Field Service Bulletin No. 20

April 2010

SBE 55 ECO Water Sampler Mechanical Modification

Procedure for Installing Shim(s)

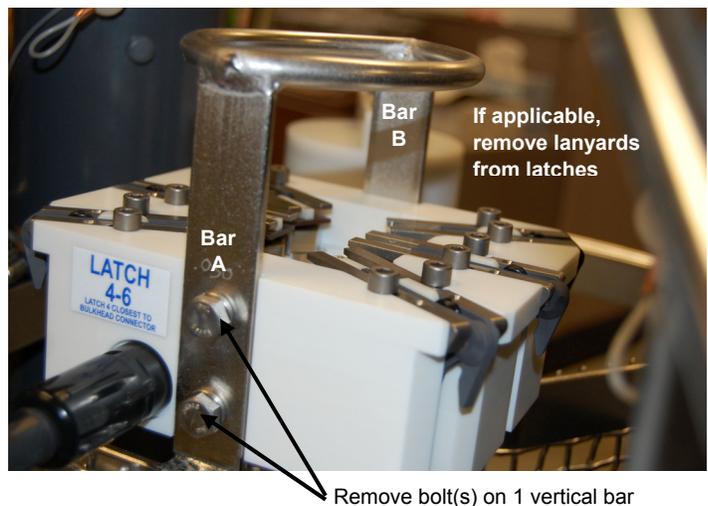
For the specified SBE 55s, the distance between the vertical bars that attach to the latching mechanism **may** be slightly too large to meet our specifications. When the latch assembly is bolted to the bars, this may result in extra stresses on the latch assembly. In the long term, the extra stress may cause cracks in the latch assembly.

1. Remove the lanyards from the latches (see the SBE 55 manual for details).
2. **On one side only (calling it Bar A)**, remove the bolt(s) attaching the latch assembly(s) to the vertical bar.
3. **On the other side (calling it Bar B)**, tighten the bolt(s) attaching the latch assembly(s) to the vertical bar, so that the latch assembly(s) is snug against Bar B.

4. Look at Bar A and check for a gap between the latch assembly and the vertical bar. If there is a gap, you will use the provided shim(s) to eliminate the gap:
 - A. **Without removing the adhesive backing from the shims**, wedge one or more shims in the gap. When the gap is closed, remove the shim(s), and set them aside.
 - B. Remove the remaining bolt(s) attaching the latch assembly(s) to the frame, and remove the latch assembly(s).
 - C. Peel the adhesive backing off the shim(s) you will use, and apply the shim(s) to Bar A, with the bottom of the shim flush to the horizontal support and the bolt holes aligned.
 - D. Reinstall the latch assembly(s), and secure it to the vertical bars with the bolts.
